## HISTORIC AND DESIGN REVIEW COMMISSION

July 15, 2015

**HDRC CASE NO:** 2015-288  
**ADDRESS:** 239 / 241 / 243 CENTER  
**LEGAL DESCRIPTION:** NCB 580 BLK 11 LOT 17 (SUNSET CENTER STREET SUBD) 2012-NEW ACCT PER SPLIT PER PLAT 9621/133-135 FILED 3/11/2011  
**ZONING:** D, H, HE  
**CITY COUNCIL DIST.:** 2  
**DISTRICT:** St. Paul Square Historic District  
**LANDMARK:** Guenther, Colin Building  
**APPLICANT:** Pam Carpenter/Seventh Generation Design  
**OWNER:** Zachry Realty  
**TYPE OF WORK:** Demolition and new construction of multi-family building  
**REQUEST:**

The applicant is requesting conceptual approval to:

1 CENTER STREET ELEVATION

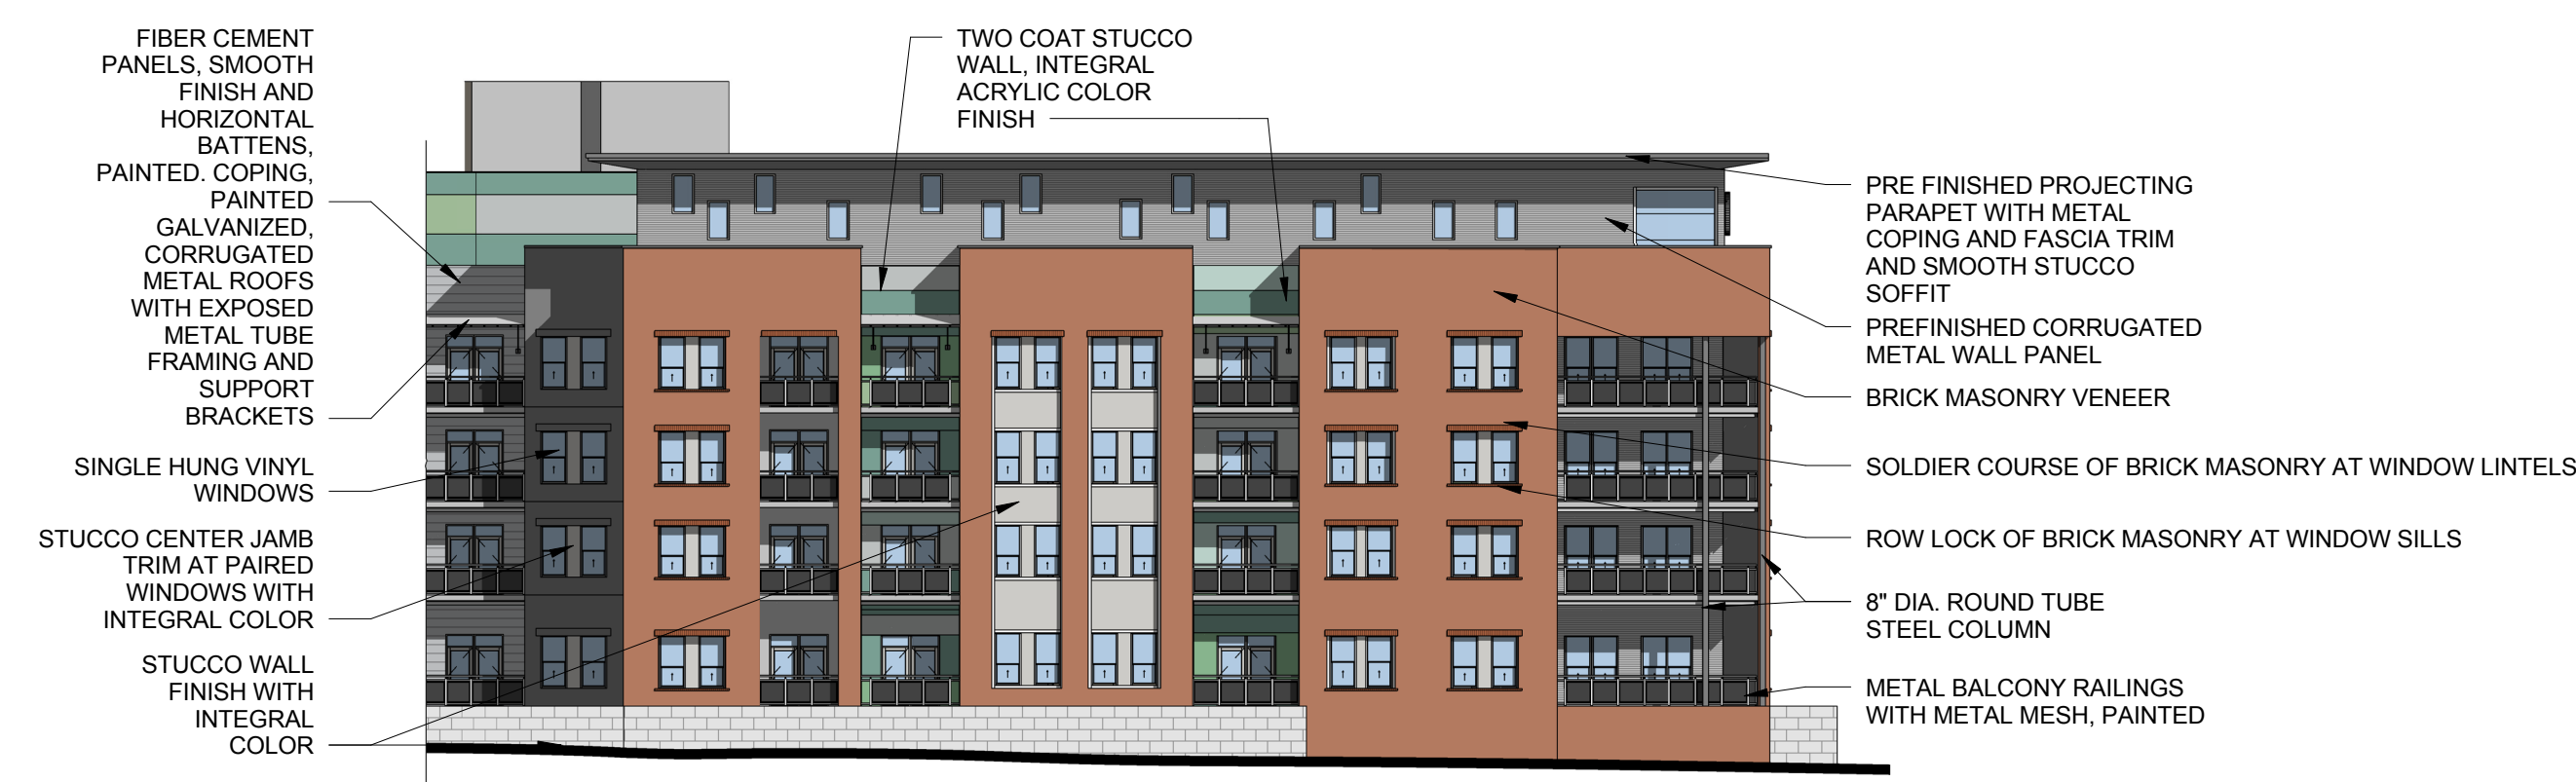
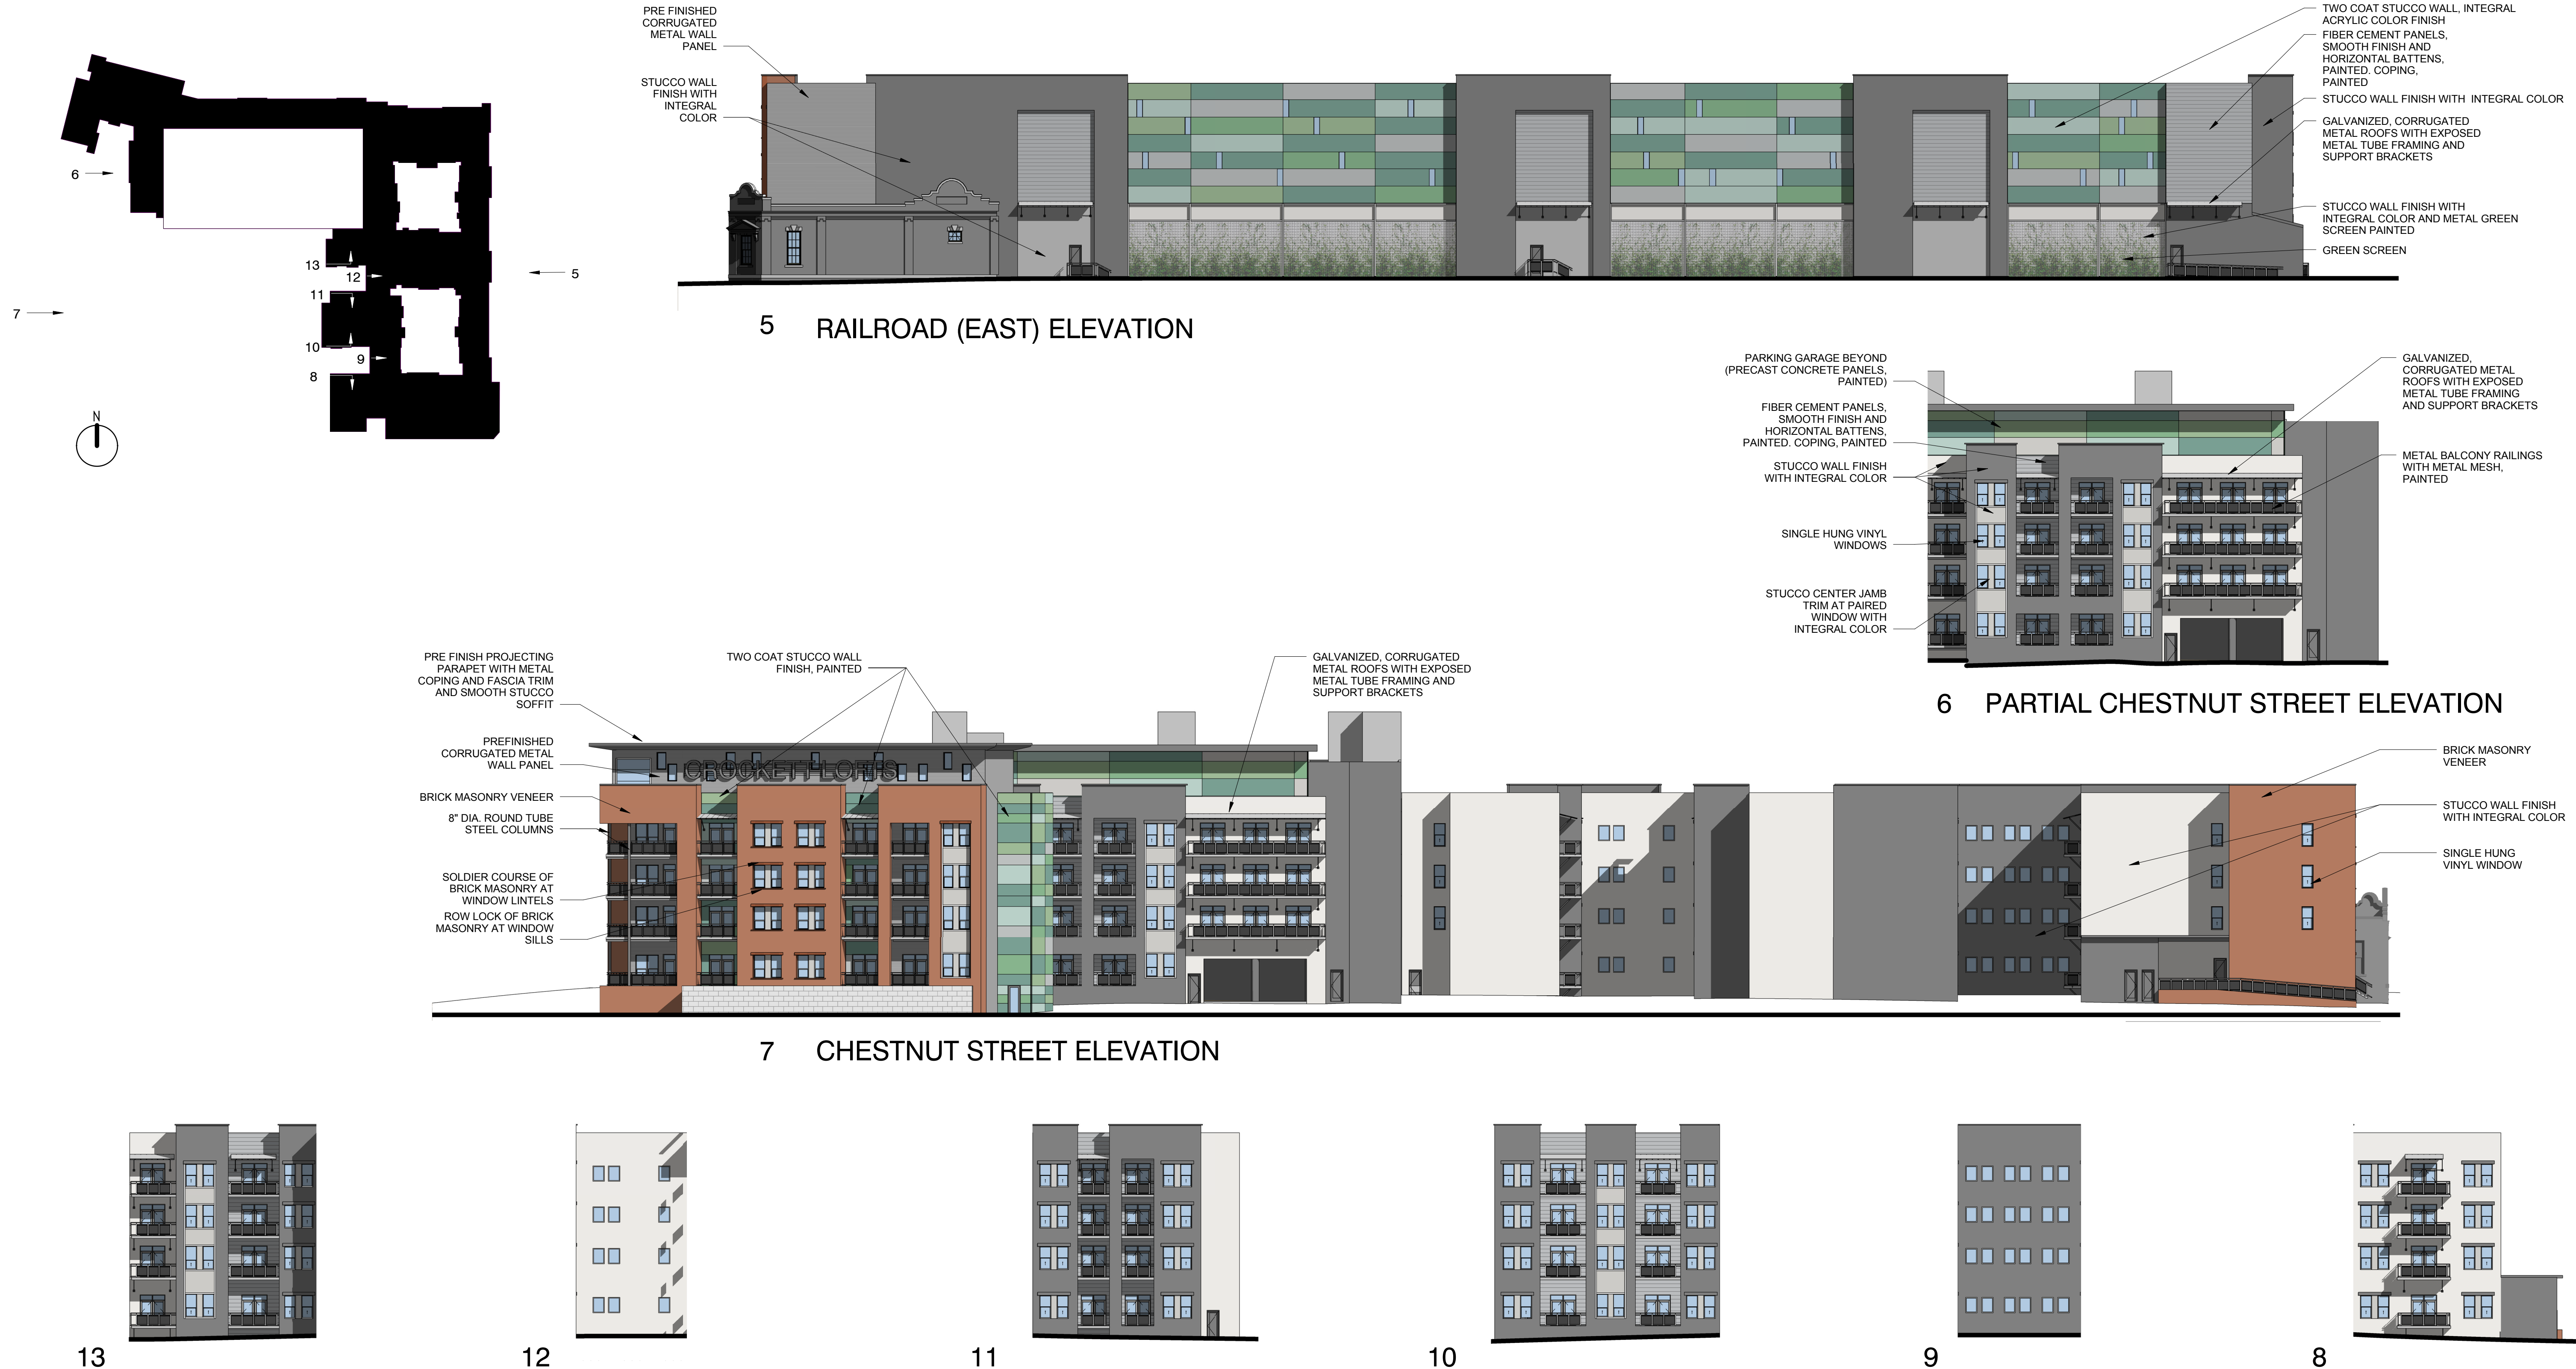
- 3c. Along Center, the applicant has proposed four levels of new construction, along Chestnut five levels and along E Crockett a mix of both four and five levels. Historically, St. Paul Square features a mix of commercial structures, most of which feature two to three floors. More recently, new construction of up to approximately twenty floors has been constructed in the direct vicinity of 241 and 243 Center. According to the Guidelines for New Construction 2.A.i., new construction should be designed in a manner in which its height and overall scale are consistent with nearby historic buildings. Specifically, in commercial districts, building height shall not exceed the tallest building on the adjacent block face by more than ten percent. The applicant's proposed height is consistent with the Guidelines.

- 3d. The proposed new construction would integrate the existing Collins-Guenther Building's structure into its design placing a four story structure immediately above and behind a one story structure. In this situation, a visual transition obtained through a step down in building height, wall plane offsets or another variation in building height should be used to minimize the direct contrast between building heights. While the applicant has proposed a separation of the new construction's façade immediately behind the existing, historic structure, this does not satisfy the previously

- mentioned requirement of the Guidelines for New Construction 2.A.ii.
- 3e. According to the Guidelines for New Construction 2.A.iii., foundation and floor to floor heights of new construction should be aligned within one foot of those of adjacent historic structures. The applicant has aligned the floor of the first level of the new construction with that of the Collins-Guenther Building, however the height at which the cornice and parapet of the Collins-Guenther Building currently exists aligns between the proposed new construction's second and third floors. This is not consistent with the Guidelines for New Construction 2.A.iii. To become consistent the applicant should align floor heights at both the first and second level. This would also facilitate a façade transition that would contribute to satisfying the Historic Design Guidelines requirements mentioned in finding 3d.

- 3h. According to the Guidelines for New Construction 2.C.ii. regarding façade configuration, the primary facades of new commercial buildings should be in keeping with established patterns. In this case, the established pattern would consist of comparable or matching floor heights, window arrangement that is consistent spacing and repetition and the aligning of column bays which would facilitate an established pattern and transition from the historic structure to the proposed new construction. At this time, the proposal is not consistent with the Guidelines.

- 3j. The applicant has proposed materials of brick, stucco, prefinished corrugated metal wall panels and painted precast panels. The St. Paul Historic District consists of contributing structures which generally all feature brick as the primary façade material; stucco and corrugated metal siding do not have a precedent as a primary façade material. The Guidelines for New Construction 3.A.v. states that corrugated metal sheeting and other contemporary materials should not be used in new construction in historic districts. The use of metal in window frames, balcony railings or other minor elements would be appropriate to separate the façade. Staff recommends that the applicant address the current inconsistencies with the Guidelines regarding materials.

3. If the demolition request in item #2 is conceptually approved by the HDRC, staff recommends conceptual approval with the following stipulations:
  - i. That the applicant address staff's concerns regarding the proposed new construction's façade arrangement in relationship to the Collins-Guenther Building as noted in finding 3e and 3h and provide updated elevations that show consistency with the Historic Design Guidelines.

- ii. That the applicant address staff's concerns regarding an appropriate transition from the Collins-Guenther Building to the proposed new construction as noted in finding 3d and provide updated elevations that show consistency with the Historic Design Guidelines.

- iii. That the applicant address staff's concerns regarding materials as noted in finding 3j and provide information regarding new materials that are consistent with the Historic Design Guidelines.
